# Bulletin

## **Mazda Mazda 3 From model year 2006 onwards**

### **Cooling capacity diminishes while driving**

Figure 1

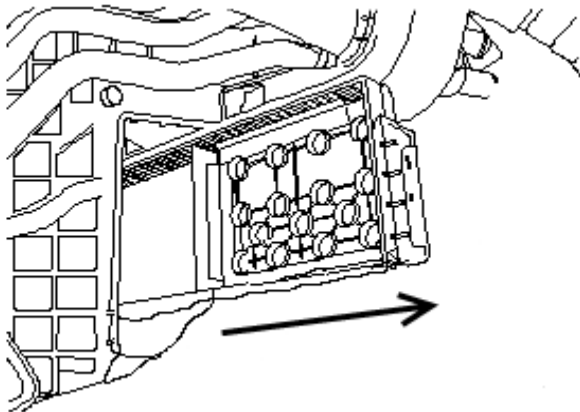
- Now take out the upper and lower filters of the air-conditioning system
- Insert the new filters with the diffusion plate (Fig. 1) and make sure that the arrows on the filter are pointing in the direction of the rear (Fig. 2). Replace the cover on the evaporator box
- Connect the short wiring harness including resistance with the plug. Then connect both with the temperature sensor on the evaporator
- Finally reassemble all the remaining parts that have been removed and run a check to test how the air-conditioning system now works
